ADVICE from The Regent's Park Conservation Area Advisory Committee
12A Manley Street, London NW1 8LT

Euston Tower 2023/5240/P Revised advice in place of 8 January 2024 advice

Euston Tower

Regent's Park CAAC views

View 02

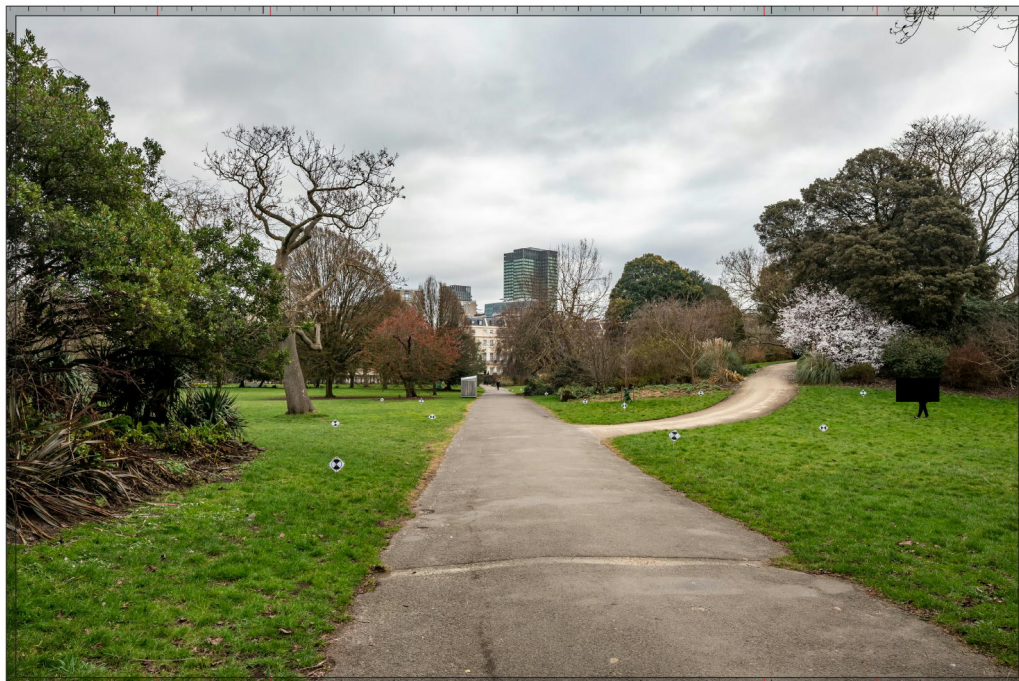
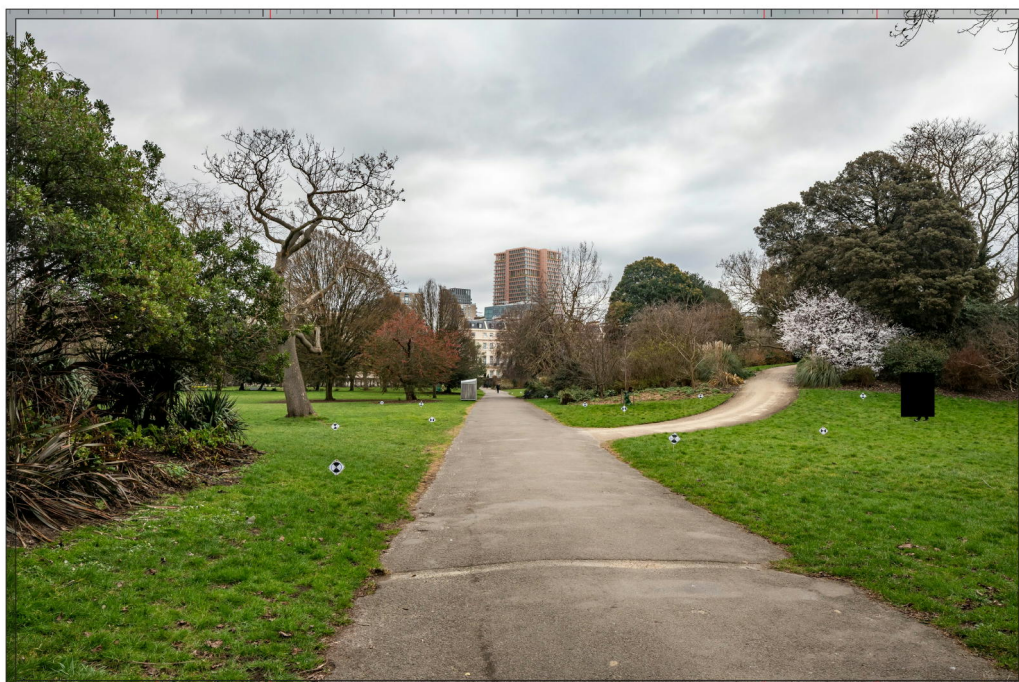
11. Reviewing the applicant's images 07 and A14, and the 3 extra images now submitted, the RPCAAC assessed both the impact of the proposed modelling of the elevations and of the colour. The RPCAAC agreed that, as seen especially in image 07 and the new images, the proposed colour markedly worsens the harm caused by the Tower. That is, the extra bulk and width of the Tower is harmful: the harm is made worse by the proposed colour.

12. Image 07 and the 3 extra images shows the existing tower blending better with the blue/grey colours of the roofscapes of the Park buildings and the luminosity of the sky. The warmer colours currently proposed for the Tower conflict with the subtler, cool colours – perhaps more characteristic of northern European light. We advise that the colours proposed for the Tower exacerbate rather than mitigate the harm to the setting of the Listed Buildings and the character and appearance of the conservation area.

13. We also advise that the modifications to the upper storeys of the Tower and its roofline increase the harmful visual impact of the increased bulk of the Tower.

14. On the basis of the images now reviewed, we advise that, given the modifications to the upper storeys and to the colour of the tower, the proposed modelling of the elevations of the tower does not mitigate the harmful impact of the increase in bulk of the tower.
